Appeal to Portland Design Commission

LU – 19 – 249975 DZM

Elke Poehling

Another Possible Solution to Issue #3

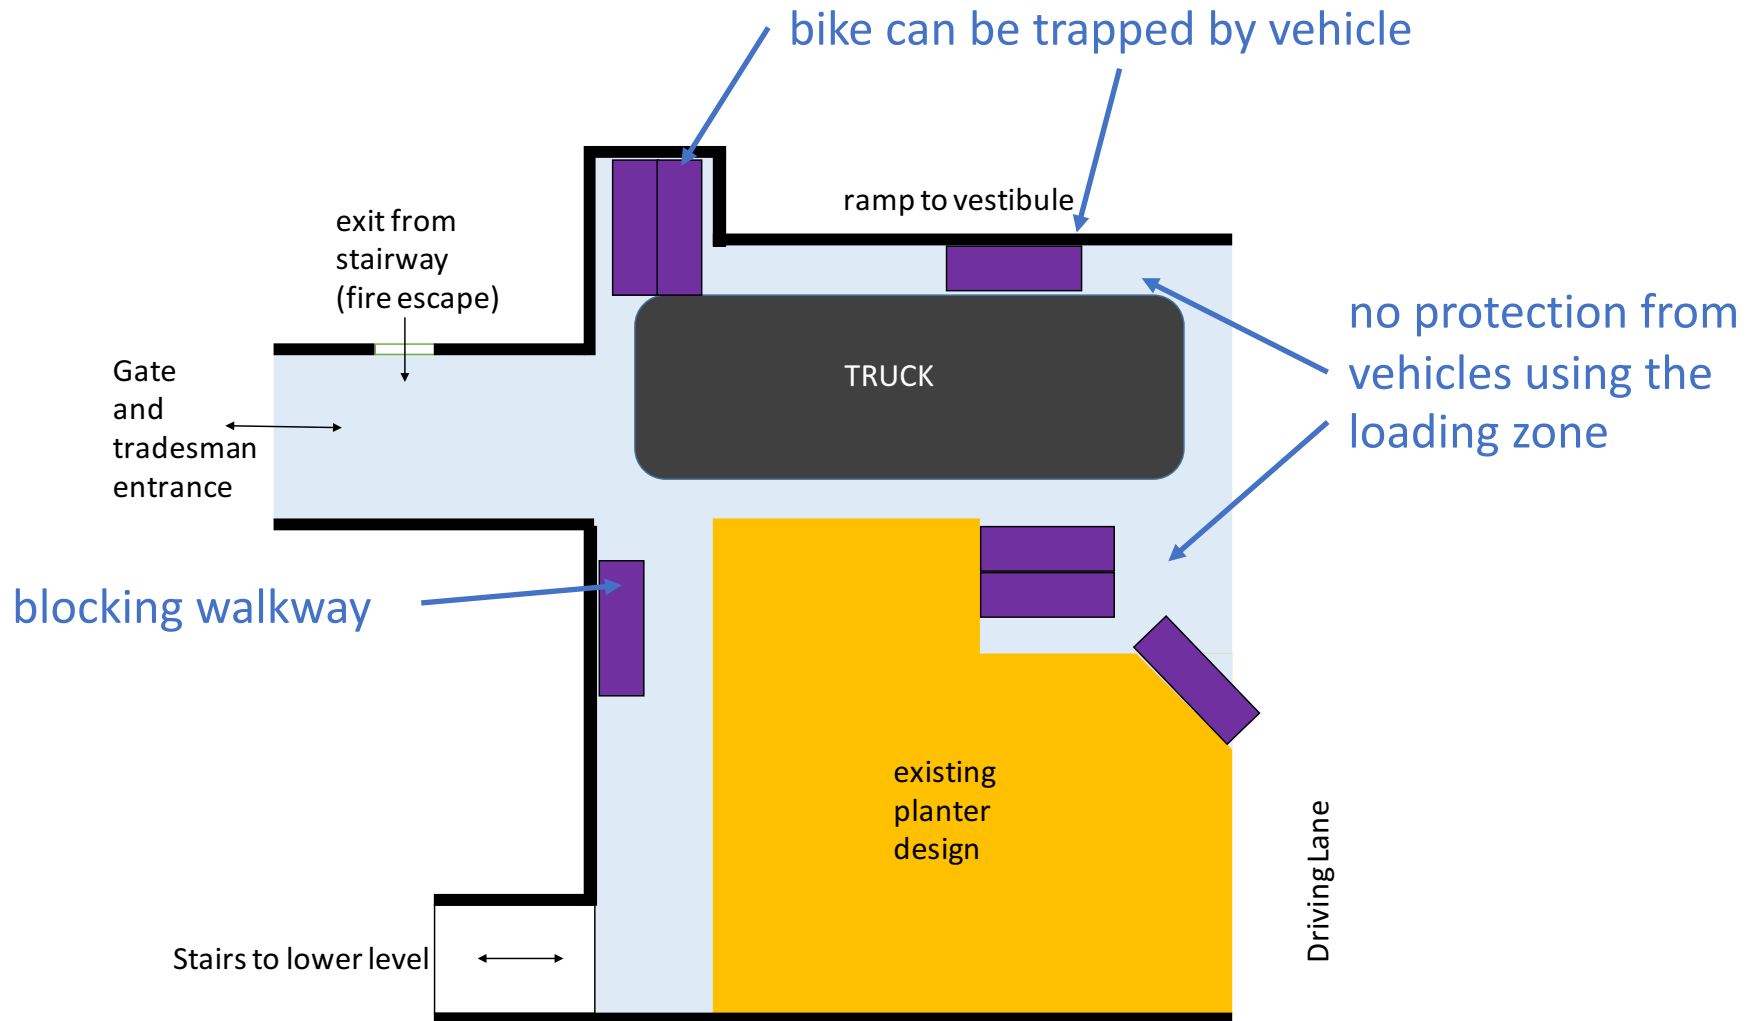
Short Term bicycle parking ... must be within 50 feet of the main entrance to the building as measured along the **most direct pedestrian access route**. (Note: same requirement in both new and old standards)

In front of the Grant gate seems like the best (only?) plan for more bike racks:

- One can argue that either the vestibule or the gate is the main entrance (the gate certainly gets more use). Either way, bike racks in the area in front of the Grant gate would be **within 50 feet of both entrances**.
- They would be **highly visible**.
- They would be **well lit**.
- They would be **safer** and **more secure** than a dark corner behind a planter.
- The **flow** in and out is **easier and safer** (as long as the path is not blocked by a vehicle in the loading zone).

Possible Solution to Issues #2 and #3

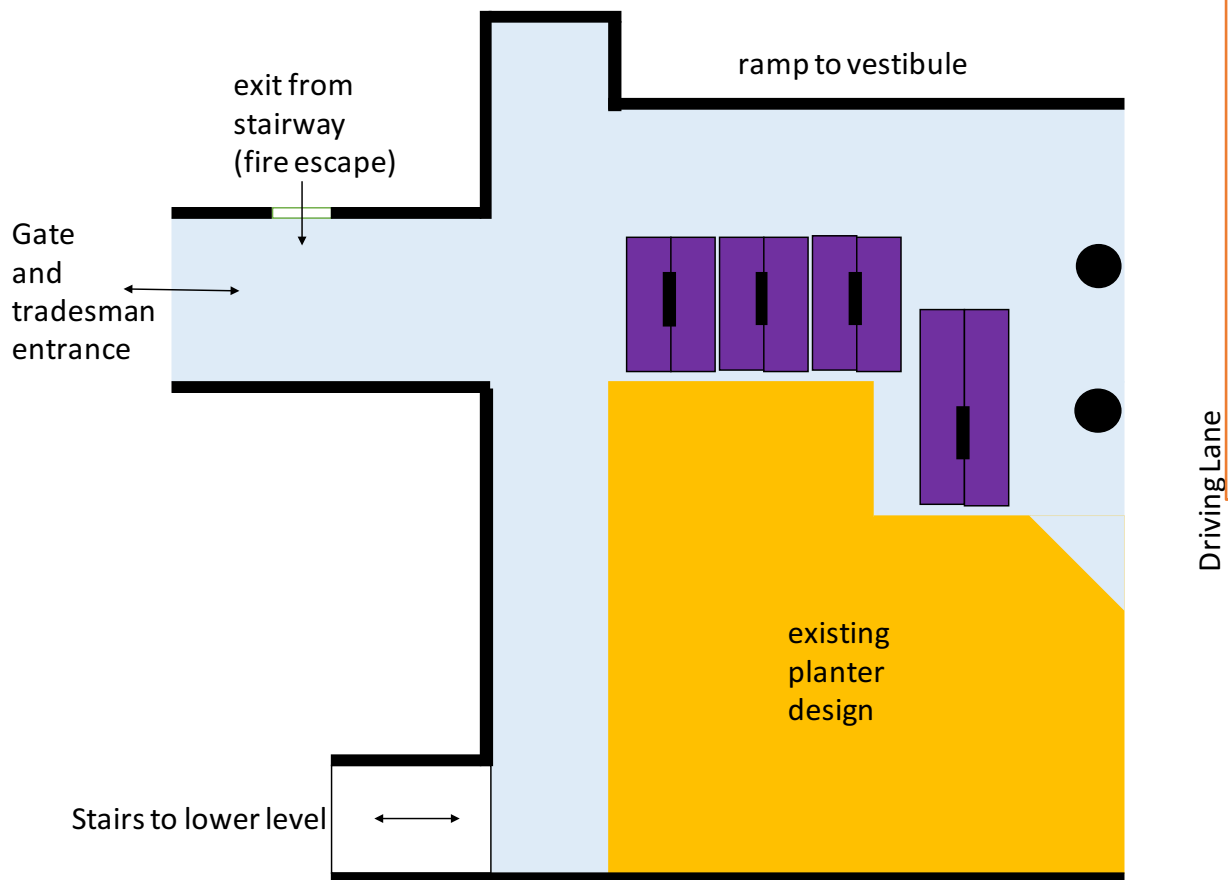
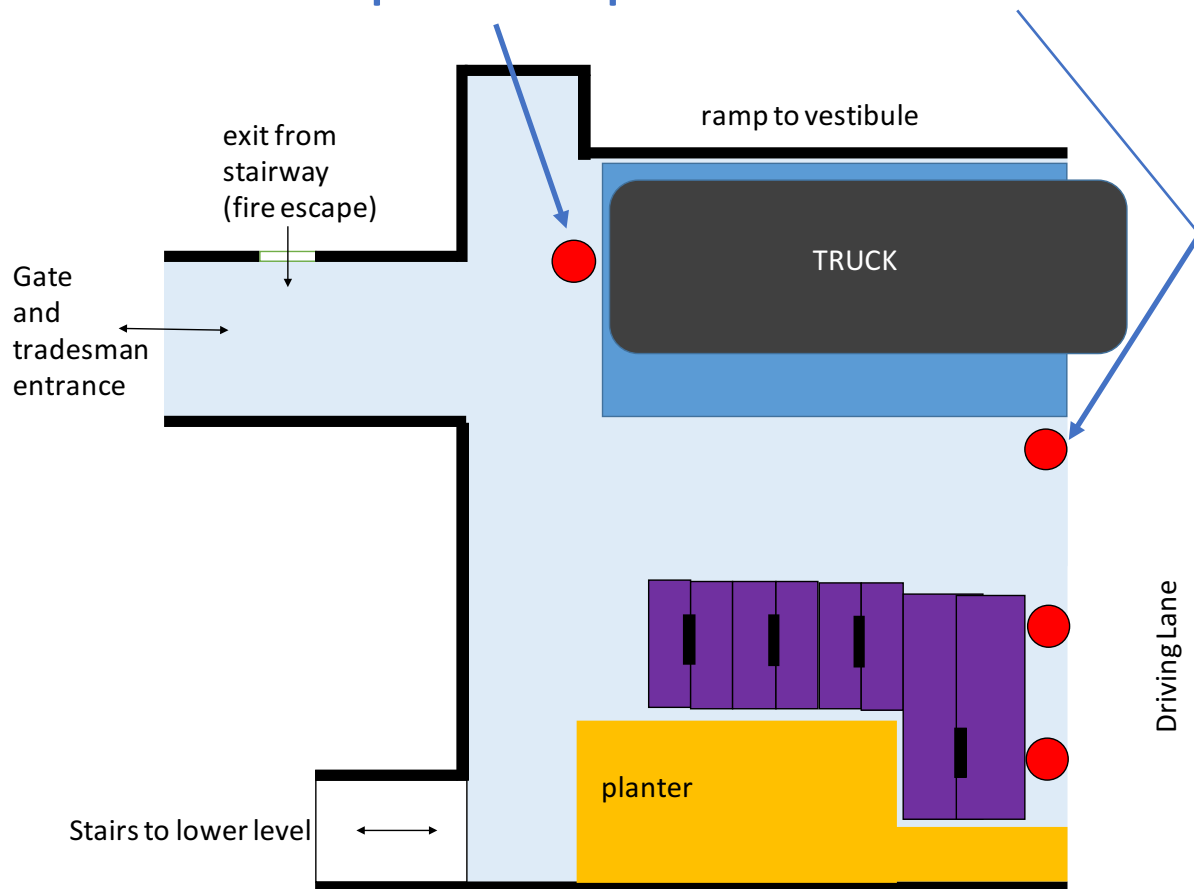
- Less convenient and less safe to transport items from car into building.
- Likely very unpopular with Grant Tower residents (they like their loading zone)

- Move loading zone to an existing parking space
- Put bike parking in place of old loading zone

Another Possible Solution to Issues #2 and #3

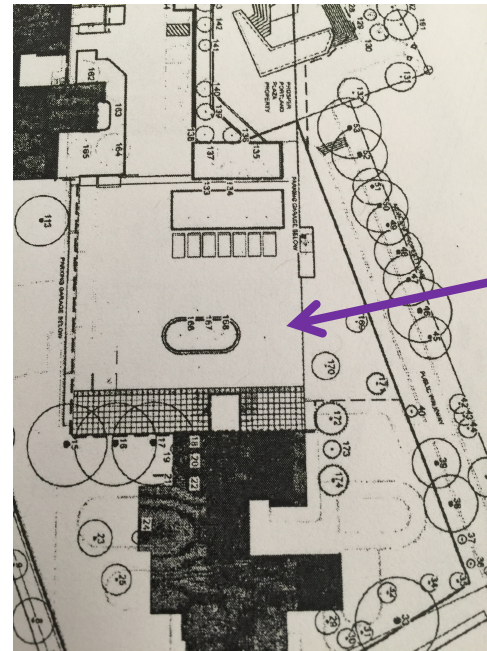
Note: Need some sort of **physical barrier** to prevent vehicles from pulling too far into loading zone, or too far to the side.

Otherwise the pedestrian path could still be blocked.

Redesign planter to accommodate all uses of the space in front of the Grant gate

Pedestrian/ADA Path Needs to be Barrier-Free

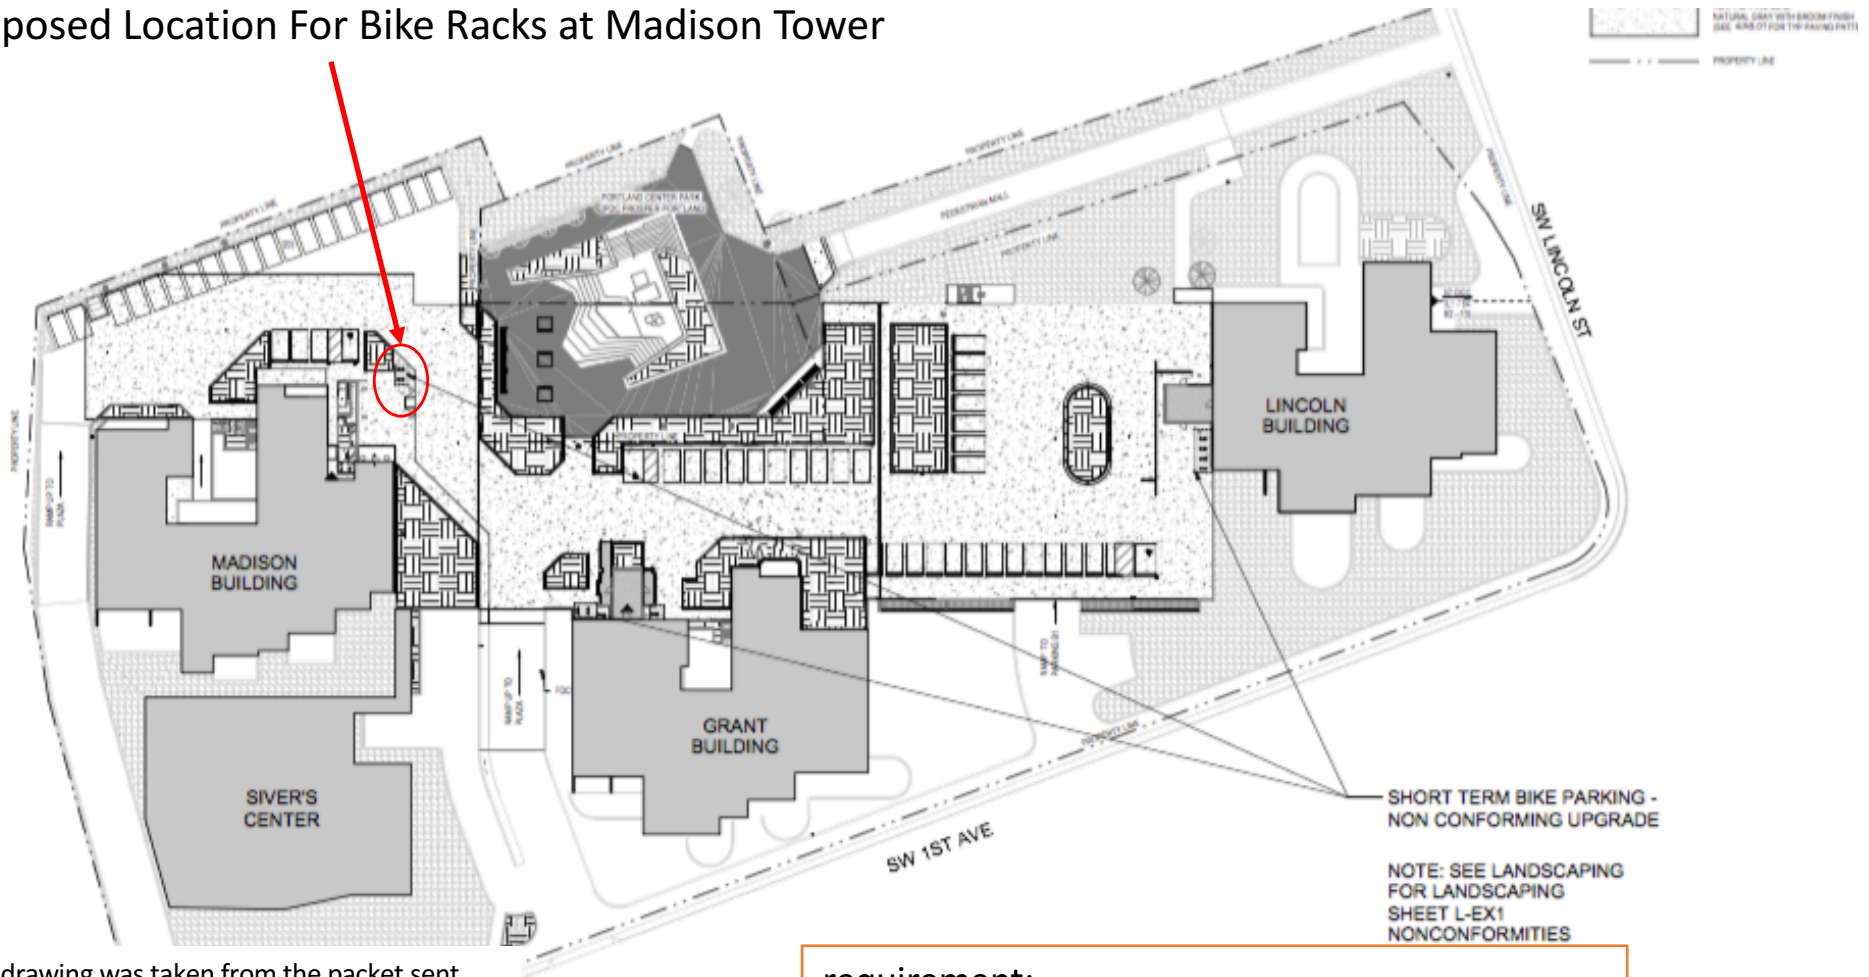
- Sometime in the history of APTCA, the space between the planters became a short-term car parking area (see pictures below).
- Sometimes cars are blocking the path.

Protected pedestrian and ADA paths cannot be designed such that they can be blocked by a legally parked car.

The planters, by themselves, do not adequately protect the path.

Even if the planters are put back into the design, another physical barrier needs to be placed to prevent cars from parking in the protected pedestrian path.
